Re: Arno Subdivision Grading and Drainage Plan
Engineer's Stamp dated 8-11-03 (J14/D146)

RE: RESPONSES TO YOUR COMMENTS DATED SEPTEMBER 18, 2003
FOR THE E.L. PORVENIR SUBDIVISION, (ARNO SUBDIVISION)
GRADING AND DRAINAGE PLAN (J-19/D37), ENGINEER'S STAMP
DATED AUGUST 11, 2003

E.L. Porvenir Subd

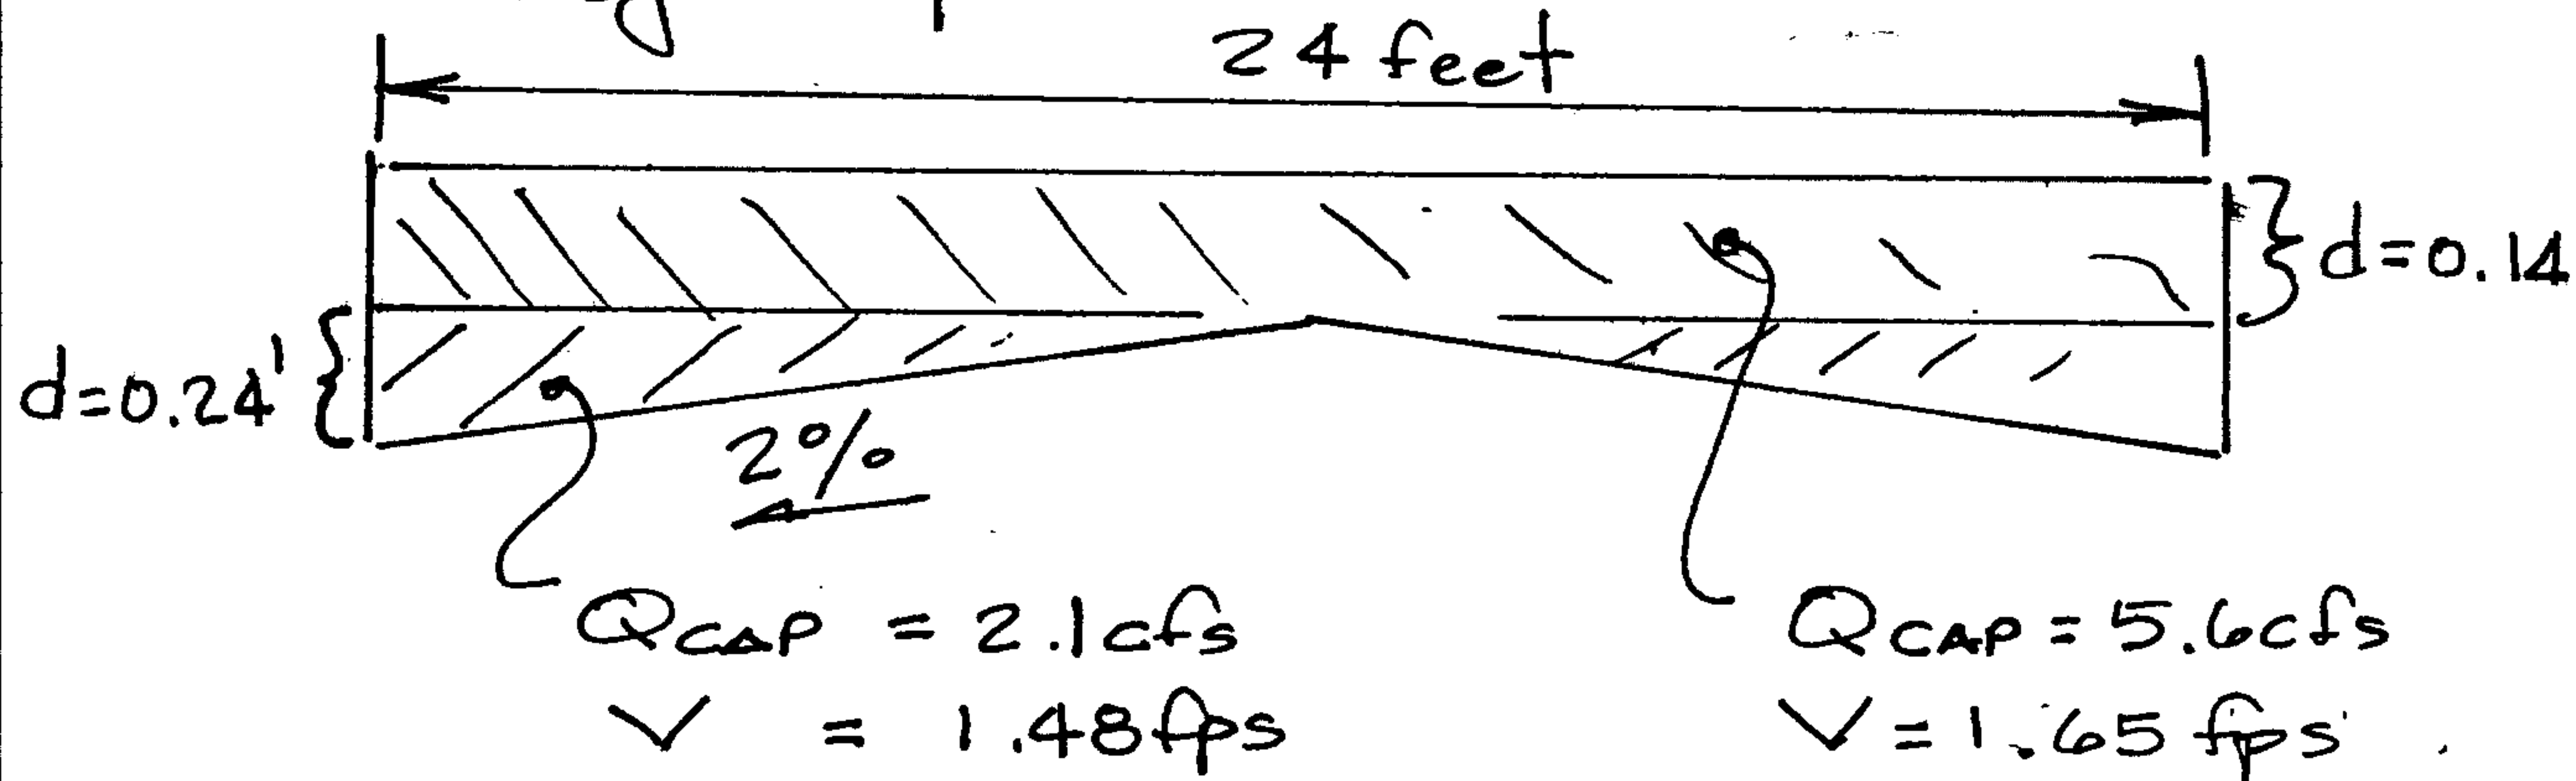
- The DPM states that the normal depth can be no higher than the top of curb and the depth plus velocity head ($d+v^2/2g$) cannot exceed 0.2 feet above the top of curb. There will need to be a transition to standard curb somewhere near Arno.
- The retaining wall must be made of masonry or concrete. Railroad tie retaining walls don't work to divert water and the City has had a fair number of complaints from homeowners whose walls have failed. Who will maintain the sediment pond and swales?
- Please provide the benchmark on the plan.

1. Please see attached calculations, the plan is to move the sidewalk behind the mountable curb for approximately 95 feet east of Arno Street in-order to maintain the velocity head within a hardscape structure.
2. As per our discussions the details for the railroad tie retaining wall show concrete placed in the hole for the railroad ties, also the requirement of depth of burial equal to height should sustain the wall for quite some time. The sediment pond and swales will be maintained by the private property owners, such maintenance language will also be included in the plat.
3. A bench mark is now included on the plan.

MOVE SIDEWALK BEHIND Mountable Curb
FOR 4 LOTS EAST OF ARNO STREET
